Serial No. 10/797,645

### Amendments to the Drawings:

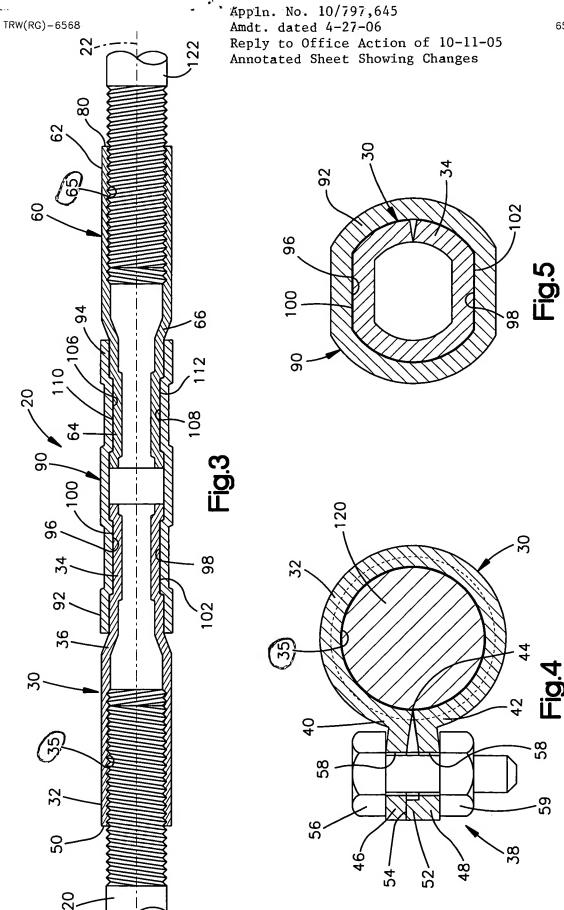
The attached sheet from the drawings includes changes to Figs. 3-5. The sheet replaces the original sheet including Figs. 3-5. In Figs. 3-5, reference character "35" is designated as the threaded portion of the first sleeve 30, and reference character "65" is designated as the threaded portion of the second sleeve 60. Fig. 5 is corrected to show the longitudinally extending seam 44. No new matter is added in these amendments to the drawings.

The drawings are corrected to designate reference character "35" as the threaded portion of the first sleeve 30, and reference character "65" as the threaded portion of the second sleeve 60. Figure 5 of the drawings is corrected to show the longitudinally extending seam 44. An annotated drawing sheet is provided that shows these changes marked in red. No new matter is added in the drawings by these changes. Therefore, the objection to the drawings should be withdrawn.
